California Energy Commission
Dockets Office, MS-4
Re: Docket No. 11-RPS-01
And Docket No. 02-REN-1038
RPS Proceeding
1516 Ninth Street
Sacramento, CA 95814-5512

SolarCity and Tesla Motors respectfully submit these comments to the California Energy Commission (CEC) in response to the proposed revisions to the Renewables Portfolio Standard (RPS) Eligibility Guidebook. Our joint comments focus on the revisions to the Guidebook that specifically relate to energy storage.

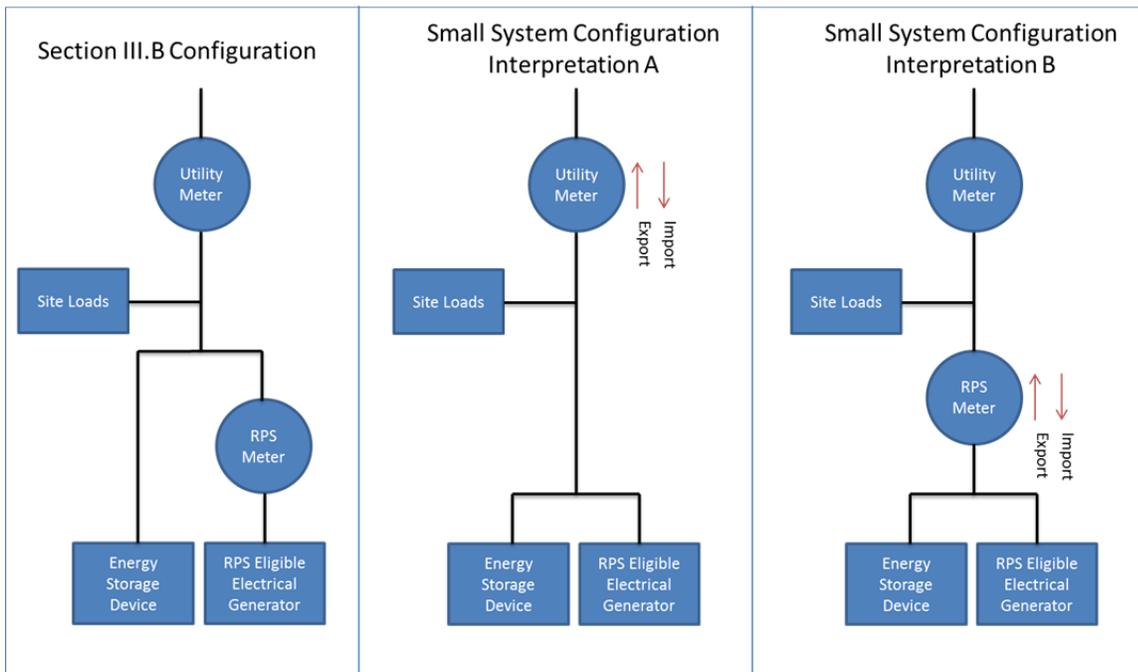
Second, there is some ambiguity in how the language in the draft revisions to the Guidebook should be interpreted as it relates to small facility metering arrangements, and by extension uncertainty regarding whether the revised Guidebook achieves the objective of reducing metering costs for small systems. The current language states, “the applicant may propose to treat only the energy leaving the facility in excess of the imported grid electricity as RPS eligible.” The figure below shows two interpretations of the small facility metering arrangement described in the revised Guidebook, as well as the arrangement described in Section III.B of the Guidebook.

In the diagram labeled “Section III.B Configuration”, an RPS Meter is placed on electrical output of the RPS Eligible Electrical Generator in order to directly measure RPS eligible generation. Energy from other sources that is stored in the battery is not included in the measurement of RPS eligible generation. Notably this is the configuration that SolarCity is currently using for our storage deployments. This configuration also meets the requirements of Net Generation Output Metering (NGOM) used in NEM tariffs, where the RPS eligible generator is metered individually for the purpose of limiting NEM export bill credits.

In the diagram labeled “Small System Configuration Interpretation A”, the energy leaving the facility and imported from the grid is measured at the Utility Meter. RPS eligible energy is computed as the net Export across the Utility Meter, which is total energy leaving the facility across the Utility Meter minus total imports of grid electricity (Export-Import). This interpretation appears to result in cost savings relative to the Section III.B Configuration since a separate RPS Meter is not required. However, current incentive programs for renewable generators, specifically the CSI program, require that the renewable generator be sized to not generate more annual energy than consumed by the site. This means that the computation of net annual Exports and thus RPS eligible energy using this configuration will almost always be zero, except in rare circumstances where a system is oversized. So, while the metering costs are lower, it would also effectively eliminate the ability of these systems to receive any renewable value for energy exported to the grid.

In the diagram labeled “Small System Configuration Interpretation B”, energy leaving the facility and imported from the grid is measured at the point that the combined generation and storage facility connects with the site electrical system. RPS eligible energy is computed as the net Export across the RPS Meter, which is total Exports minus Imports. Because imports from other sources are always subtracted from the total energy export, the RPS eligible energy computed using this method will never exceed the energy generated by the RPS Eligible Electrical Generator by itself.

Because the metering arrangement in Small System Configuration Interpretation B will underestimate the renewable portion of the exported electricity in all possible cases, we believe this arrangement should be allowed, along with the Section III.B Configuration, for all system sizes. Unlike Interpretation A, Interpretation B would allow the facility to receive credit for renewable energy exported to the grid; however, because it requires a separate RPS meter, it does not reduce costs over the Section III.B Configuration SolarCity currently relies upon.

In order to reduce costs for small systems, we propose small systems be allowed to use lower cost, device-internal metering adhering to the accuracy and data collection requirements in the CSI Handbook. The CSI Handbook provides a standard for +/- 5% accuracy internal measurement for systems less than 30 kW. Additionally, it defines requirements for data collection and validation under the Performance Monitoring and Reporting Service (PMRS) and Performance Data Provider (PDP) requirements. This same standard for internal measurement accuracy of a generating system and data collection requirements should be applied for determining the RPS eligibility of energy discharged from the facility. In effect, this would mean using device internal meters in lieu of the RPS meters shown in the diagrams above. To the degree the CEC believes this standard is insufficient, we believe post-measurement adjustments could be explored as a backstop, rather than requiring, in all circumstances, a more costly metering solution.
